**PLANNING APPROVAL &
SUBDIVISION STAFF REPORT****Date: November 7, 2013****NAME**

Knollwood Subdivision

Planning Approval to allow a 150' cell tower in a B-2, Neighborhood Business District, and Subdivision approval to create two legal lots of record from an existing lot of record.

DETAIL SITE PLAN

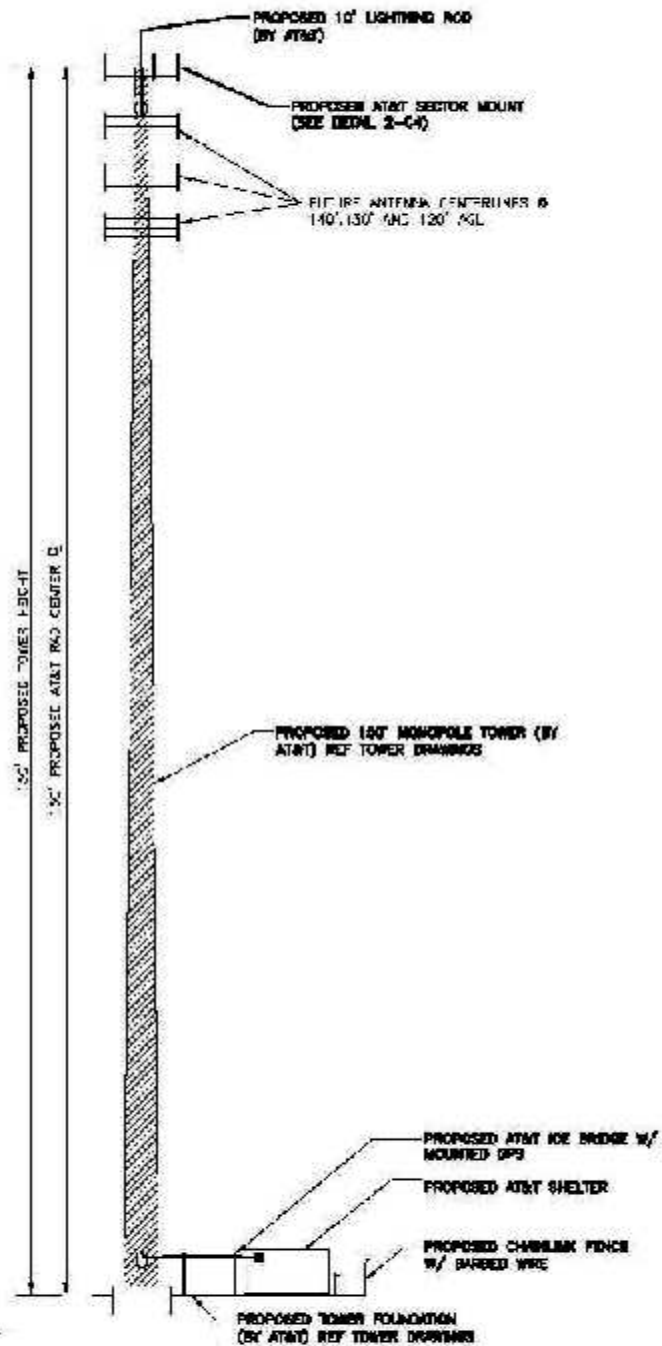
The site plan indicates the tower lease parcel to be 30' West of the 25' ingress/egress easement. Access to the parcel is across a paved 30' ingress/egress easement between the parcel and the 25' easement. A compliant vehicle parking space and turn-around are indicated on this access parcel. A chain link fence topped by barbed wire around the equipment compound is indicated. It should be noted that barbed wire fencing is not allowed in a B-2 District. Unless the applicant can provide documentation that the barbed wire fencing is required by Federal Communications

Commission (FCC) regulations, the barbed wire should either be eliminated from the site plan, or a variance to allow such should be obtained. Also, only a contiguous hedge of evergreen shrubs is indicated around the inside of the compound. If the Tree Planting Variance should not be granted by the Board of Zoning Adjustment, the site plan should be revised to indicate the required tree plantings. And due to the site's proximity to residential use, a 6'-high wooden privacy fence along the South side of the compound should be required.

It should be noted that the tower elevation drawing indicates the top antenna segments to extend above the proposed 150' elevation. The over-all height of the communications equipment/structure (antennae/tower) should not extend above the proposed 150'. If design constraints do not allow the lowering of the antennae, this application should be revised to allow the required height above 150'.

- 1) revision of the tower height drawings to indicate the maximum height of the tower/antennae to not exceed 150' over-all height, or the revision of this application to allow the required over-all height for adequate communications operation;

- 2) revision of the site plan to indicate the lease area lot configuration to correspond with the lot configuration as per the Subdivision;
- 3) revision of the site plan to eliminate the barbed wire fencing atop the chain link fencing around the equipment compound, or submission of documentation from the Federal Communications Commission verifying that the barbed wire fencing is required, and the submission of a Fence Variance to the Board of Zoning Adjustment;

- 4) revision of the site plan to indicate compliant tree plantings within the lease area;
- 5) revision of the site plan to provide a 6'-high wooden privacy fence along the South side of the lease area;
